St Michael's Place Masterplan, Huyton Town Centre

Transport Assessment Addendum

A25008

1. Introduction

Figure 1 - DfT Connectivity Tool Assessment

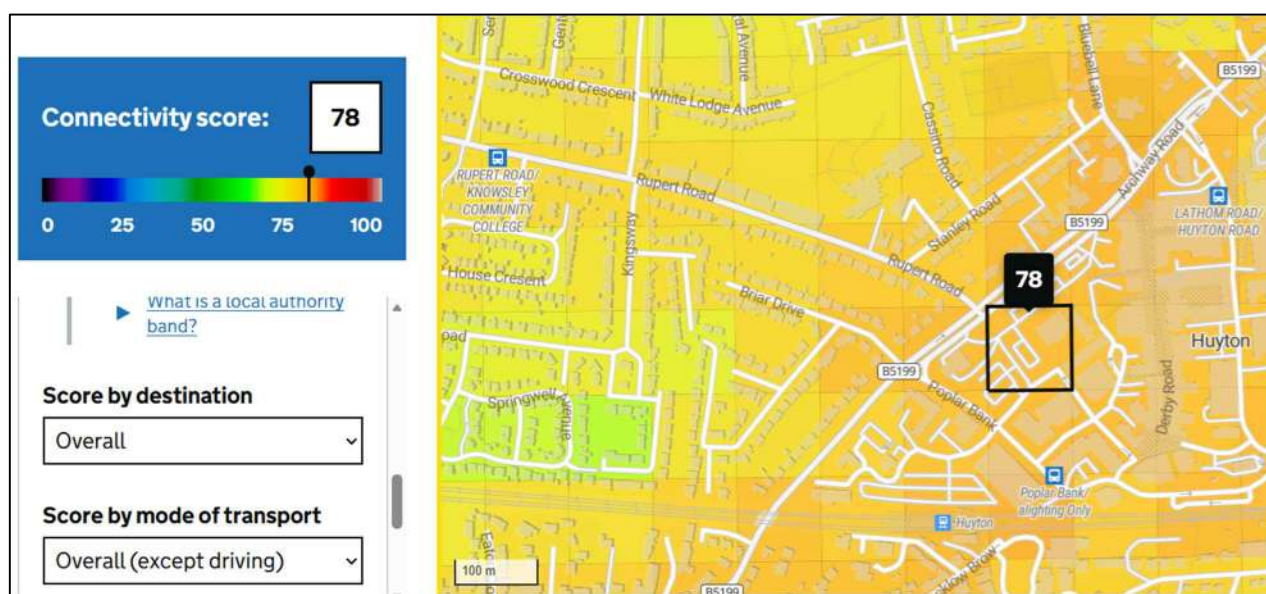
- 3.10. In terms of considering whether the existing public transport network has the capacity to absorb the displaced trips in more detail, Astute have reviewed the Department of Transport's (DfT) Connectivity Tool, which provides information on a site's level of accessibility by all modes of transport for all journey purposes. This assessment compares the site's connectivity with all other areas within Knowsley and the Liverpool City. The output of this assessment (overall except driving) is provided in **Figure 1**.

- 3.11. The above assessment scores the site around 78 and it is within Band A, which is the highest band for connectivity across KMBC. It can be concluded therefore that the site location is well suited for supporting travel to / from Huyton Town Centre using public transport and active travel modes.

Figure 2 - Coach Drop-Off Arrangement on Civic Way

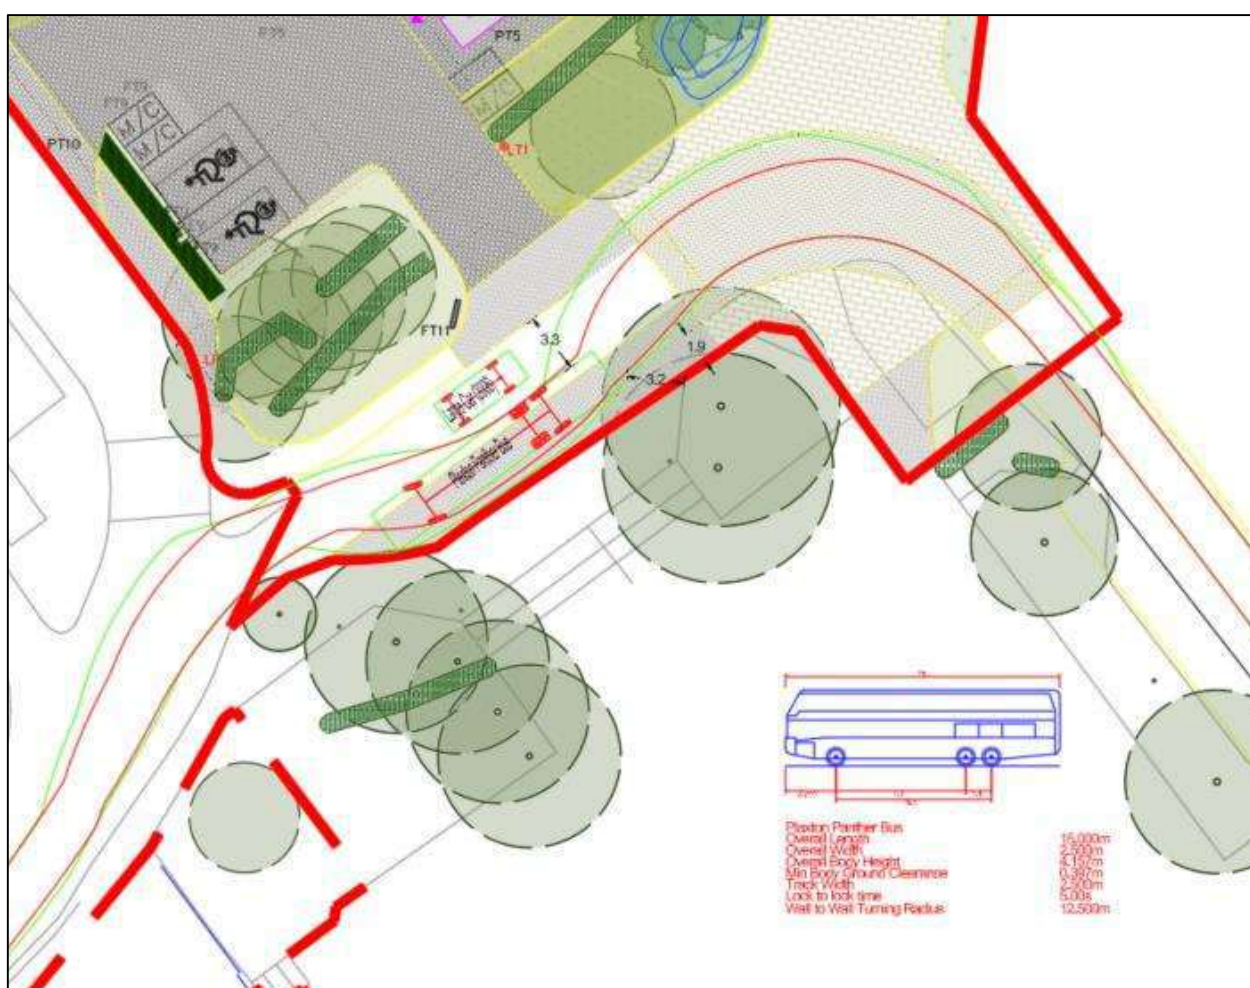
Servicing - Coach Drop-Off on Civic Way - The comments from the LHA are provided in the Highways Consultation Response issued on the 27th April 2026.

- 3.55. The above provision will also provide a suitable location for accommodating mobile health units.
- 3.56. The St Michael's Place development proposals will change the nature of the one-way section of Civic Way due to the displacement of the surrounding surface car parks in this part of the town centre, and as a result the future vehicle movements using this route will be minimal and mainly limited to servicing activity linked to the adjacent development plots. As discussed at the meeting with the LHA on the 27th July 2026, there is the potential opportunity to review changes to the existing layout to provide a shared surface route / controlled pedestrian zone on this part of the highway network by the LHA and / or as part of future reserved matters applications (once Plots 2B and 3 are completed).

Figure 2: Summary of Recorded Traffic Flows - Lathom Road ATC, June 2025

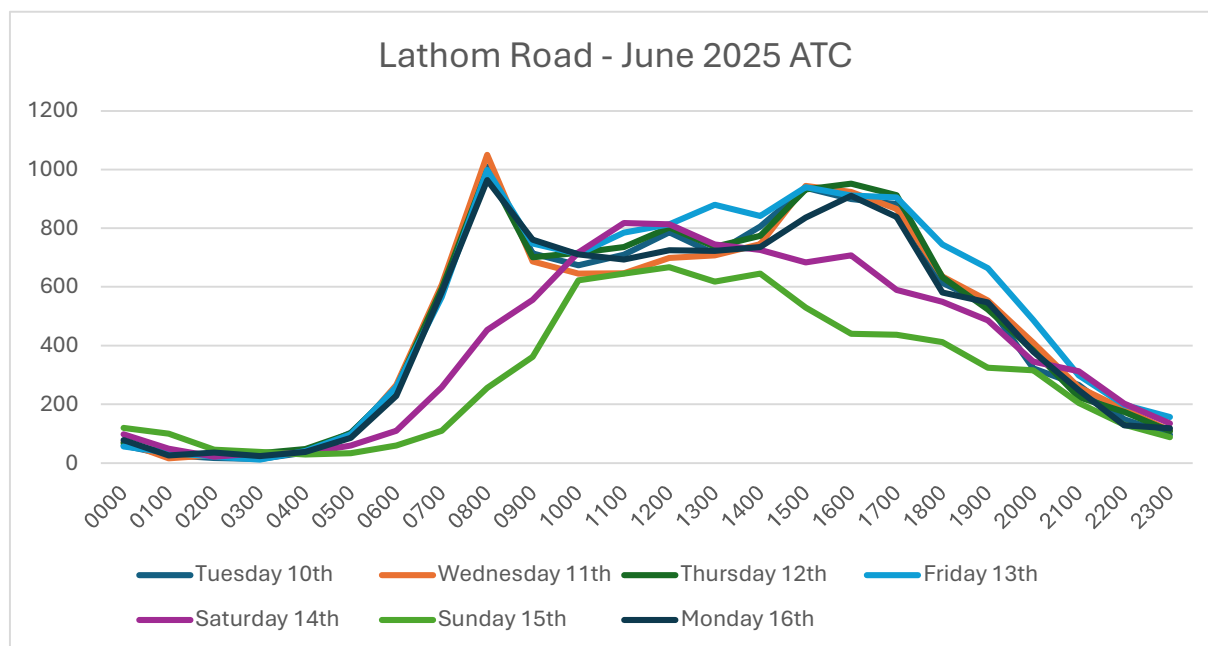
Baseline Surveys and Peak Hour Identification - The LHA requested additional clarification in respect of the traffic surveys and peak hours adopted for the assessment presented in the TA.

- 4.19. **Figure 2** confirms that the adoption of weekday AM (08:00-09:00) and PM (16:30-17:30) peak periods for the assessment is appropriate.

Figure 3: Example Enabling Works Site Compound and Parking Strategy

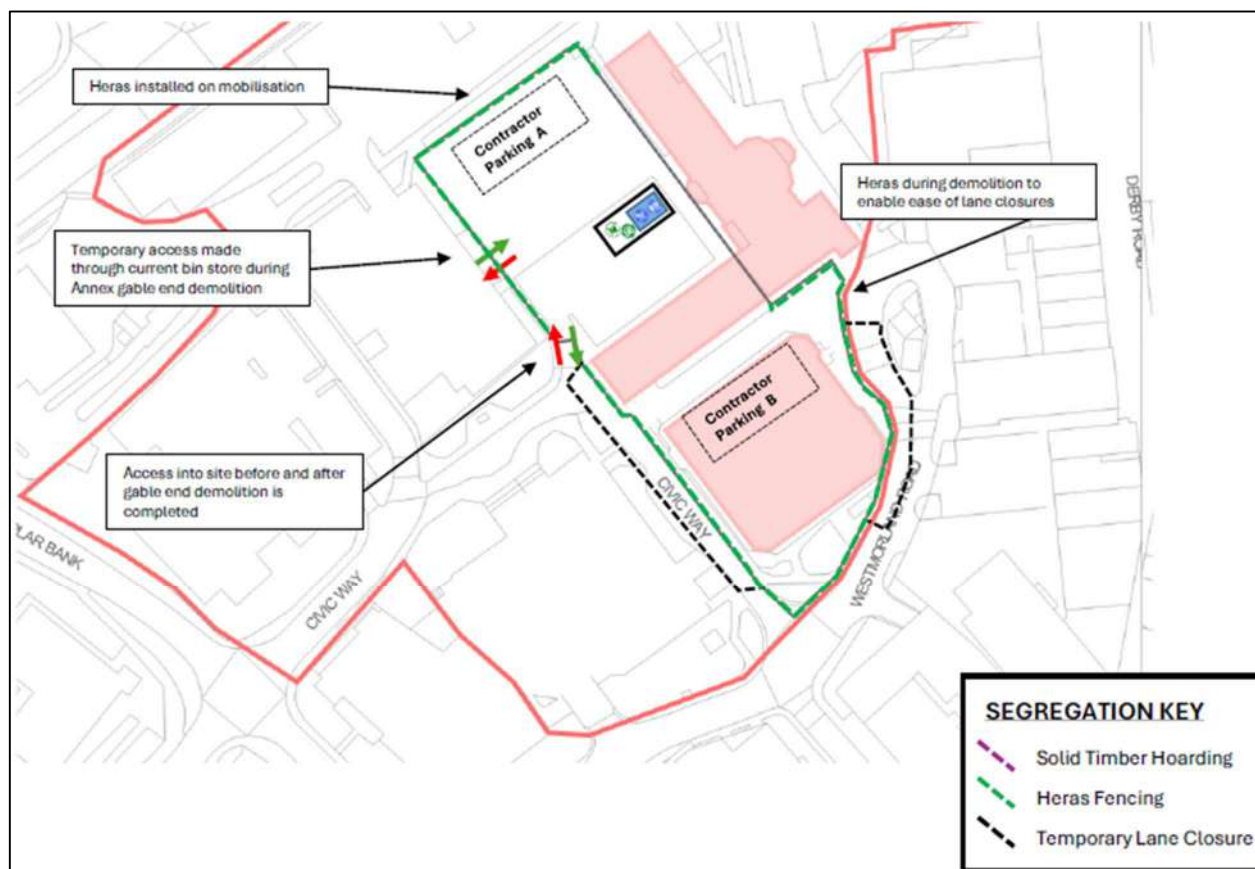
Construction Phasing Parking - The latest comments from the LHA are provided in the Highways Consultation Response issued on the 5th June 2026.

- Contractor site set up and parking will be kept within the hoarding and working zones for the Enabling Works Phase and will be adapted as required to respond to the proposed phasing of the works. The finalised strategy will be confirmed within the Enabling Works CEMP, which will be completed and submitted to discharge the relevant Enabling Works pre-commencement condition following the selection of the preferred Enabling Works contractor.
- Complying with the approved CEMP and parking obligations will be a contractual requirement for the Enabling Works contractor.
- An example of a proposed Enabling Works site compound and parking strategy, which aligns with the above strategy and provided by one of the tendering contractors, is shown in **Figure 3**.

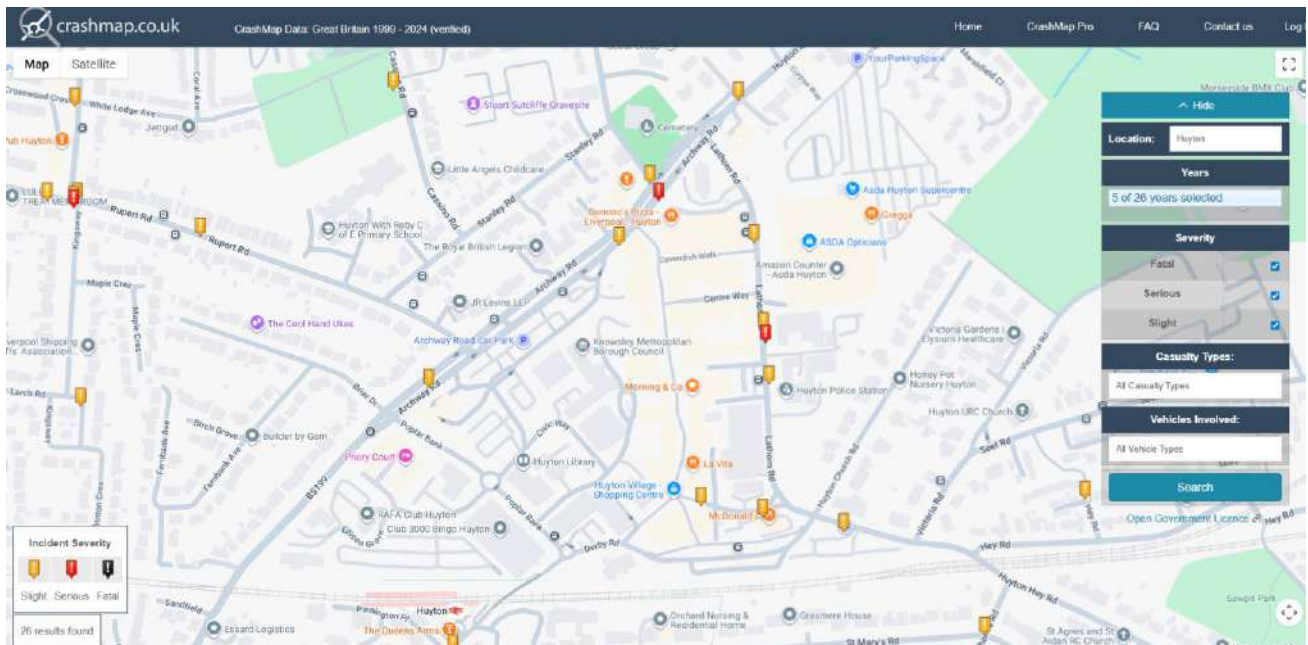
- There is currently no appropriate pedestrian link and pedestrian crossing facilities from the proposed development / town centre into the Asda petrol station which includes a small convenience store, therefore, it is recommended that this is investigated, as the provision of a hotel may increase the likelihood of pedestrians wishing to access the convenience store. Astute response - potential improvements to pedestrian facilities at this location will be considered further and proposed as part of the layout design of the adjacent Plot 5 (part of the outline element) and the associated future reserved matters application, however it is important to note that there is a third-party land issue in this location that would likely impact on the scope / feasibility of such a proposal.

- There is currently no appropriate pedestrian link and pedestrian crossing facilities from the proposed development/town centre into the Asda petrol station which includes a small convenience store, therefore, it is recommended that this is investigated, as the provision of a hotel may increase the likelihood of pedestrians wishing to access the convenience store.
